SUBJECT: Bulletin "C" Dated May 7, 2020
PROJECT #: A1310-00
DESCRIPTION: Restoration Upgrades to Exterior Building Envelope
State Office Building - 135 Hanover Street
Trenton, Mercer County, NJ

PROJECT#: A1310-00 Restoration Upgrades to Exterior Building Envelope
State Office Building
135 West Hanover Street,
Trenton, Mercer County, N.J.

BULLETIN “C”

DPMC Restoration Upgrades to Exterior Building Envelope

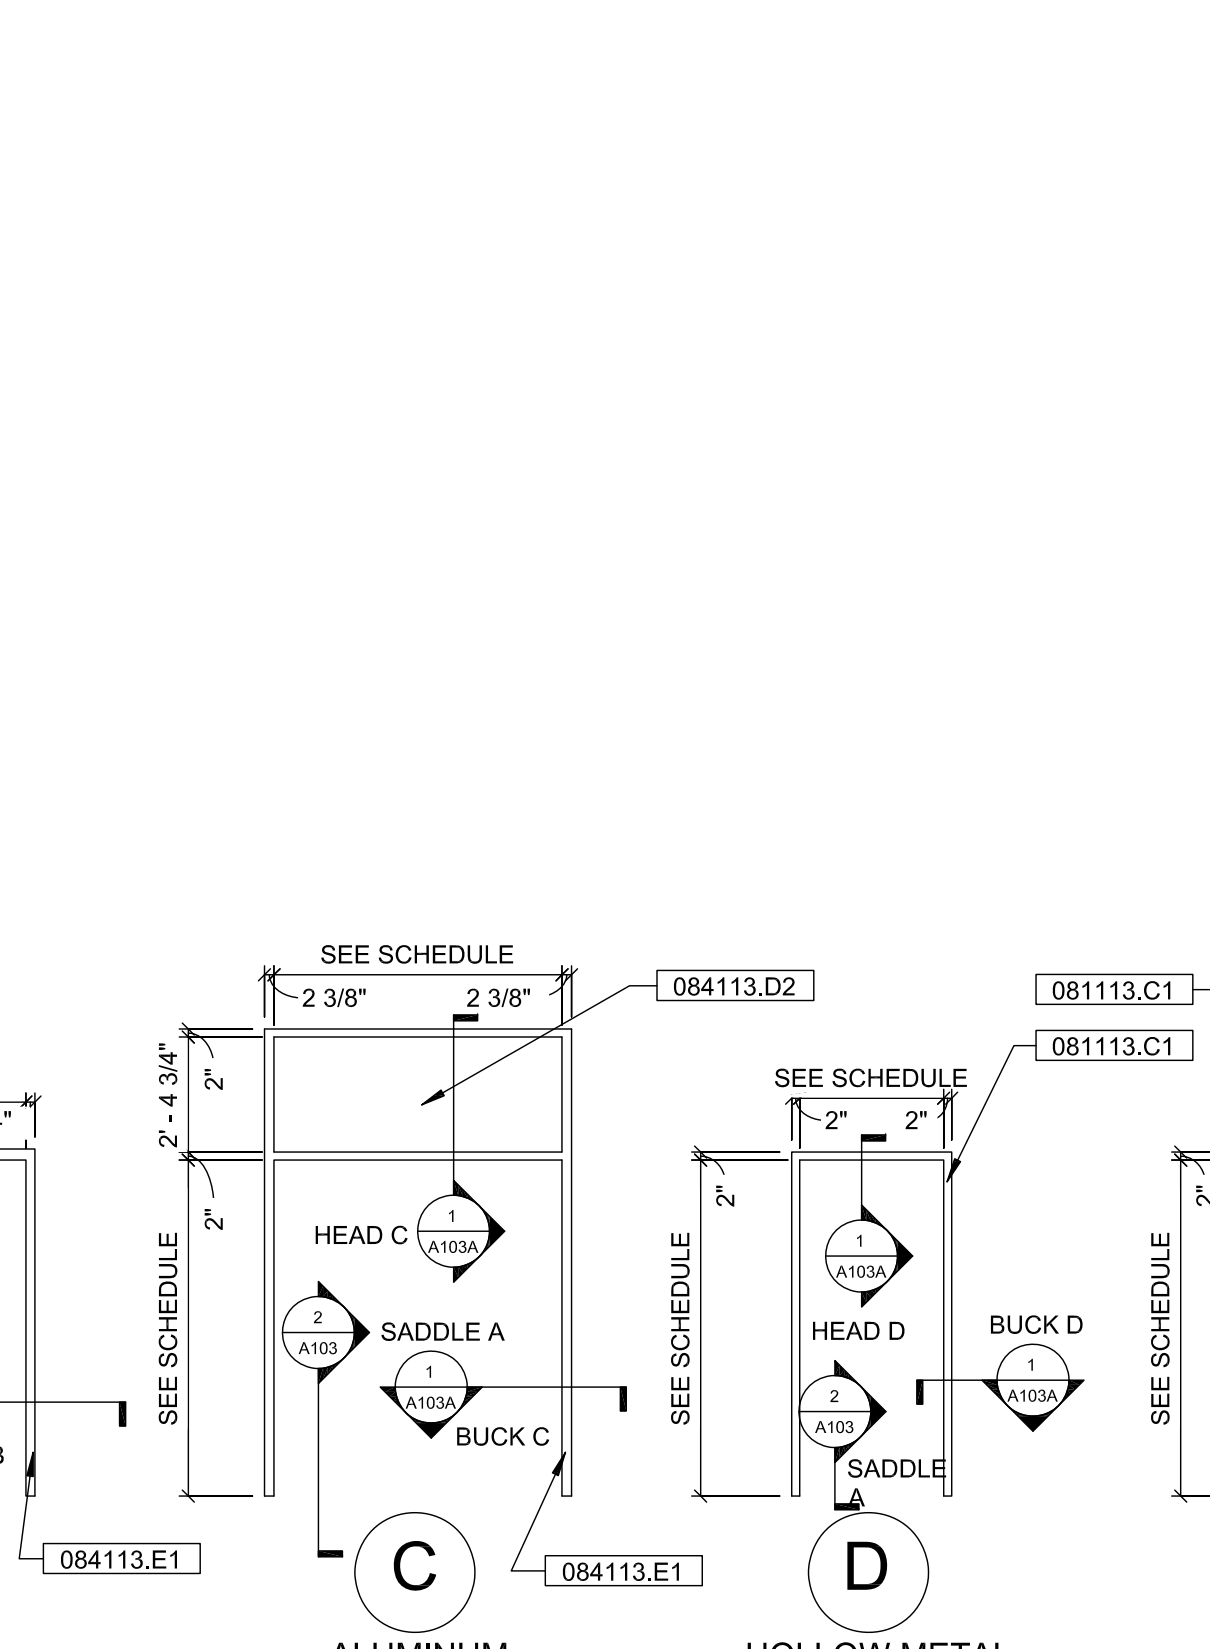
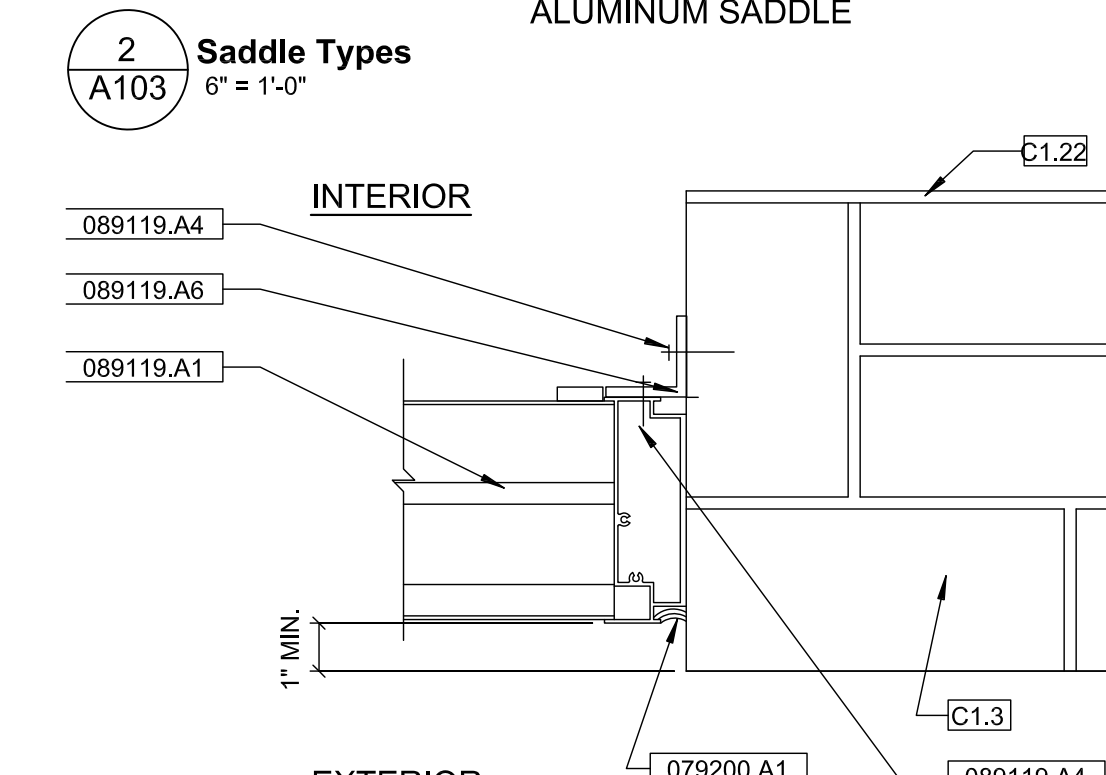
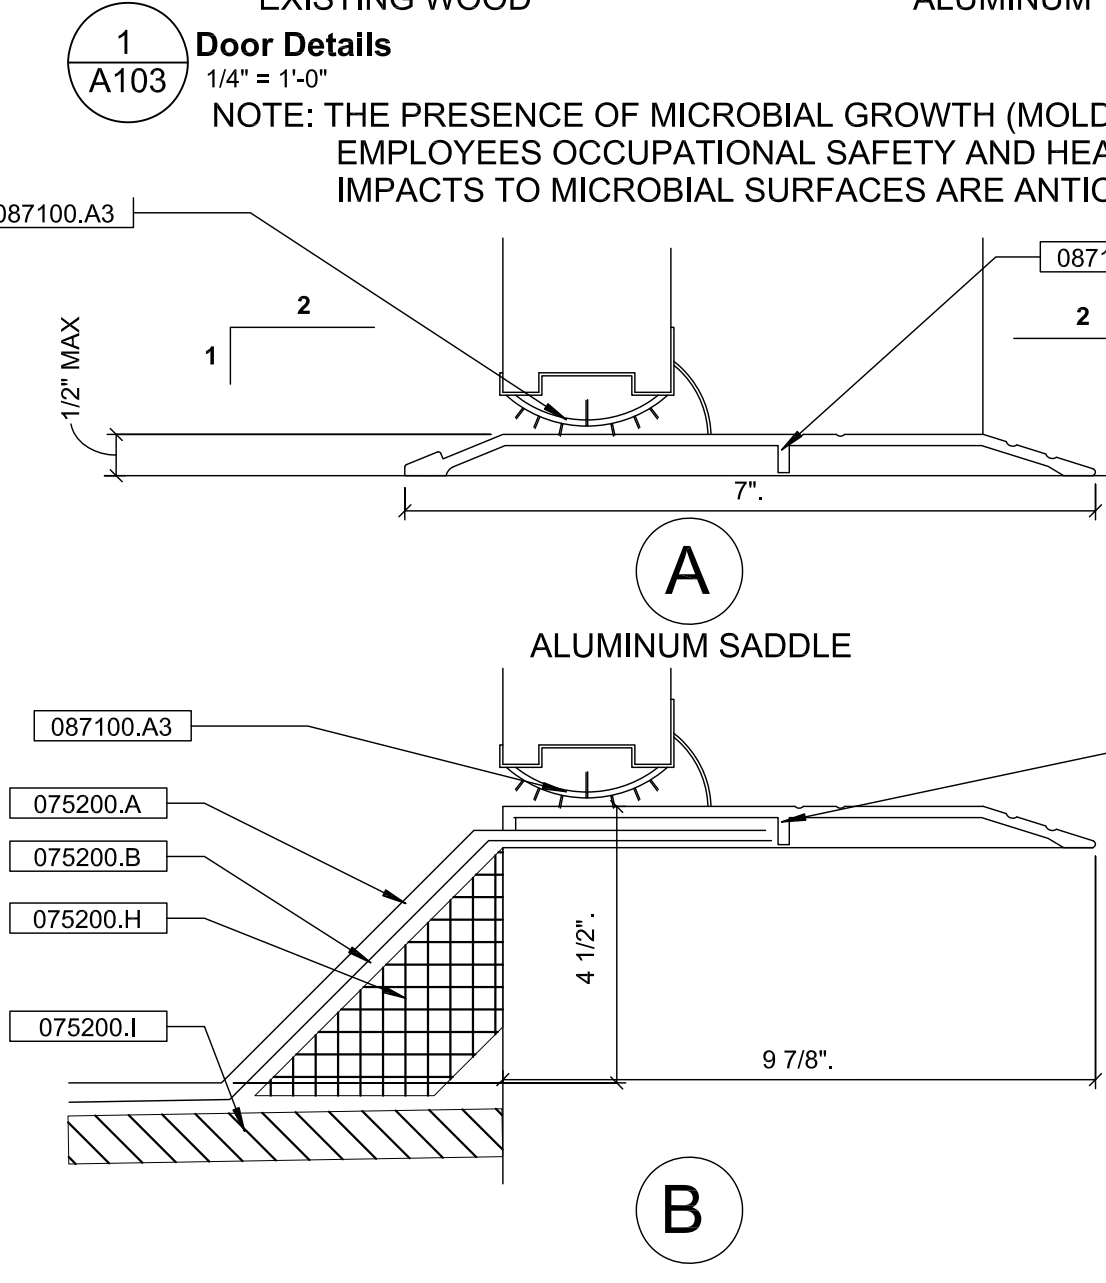
1. Are Marvin Windows an acceptable manufacturer for the replacement windows?
RESPONSE: Marvin Windows is an acceptable manufacturer for the new windows. See attached “Revised Drawing A103”, “Revised Drawing A200”, “Revised Drawing A201” and “Revised Specification Section 085250” for more information.
2. Is there any underground plumbing work required?

10. It appears that the interior side of the windows is pre-finished by the manufacturer—Are the header, jamb and sill extensions per detail 6/A103 pre-finished too or do they get painted on site

7. Section 085250, page 4, paragraph H specifies “3 ½” profiled brickmould casing with 2 1/8” projected sill nosing with end caps and frame expanders.” The window details on the window schedule on Sheet A103

shows head and sill flashing with metal wall panels. These details do not show any casing or subsill (sill nosing). The elevations also do not show any casing or subsill. Is Marvin clad casing and subsill required on this building?

14. On the window types on Drawing A-103, there is a window Type 'C' shown. On the floor plans and elevations no window type 'C' is called out

RESPONSE: The header, jamb and sill extensions should be prefinished.

RESPONSE: All penthouse windows will not have the profiled brickmould casing and projected sill. Only the windows where brick is present will have the profiled brickmould and the projected sill nosing.

RESPONSE: Delete all reference to Window Type 'C' from the drawings and specification. See attached "Revised Drawing A103".
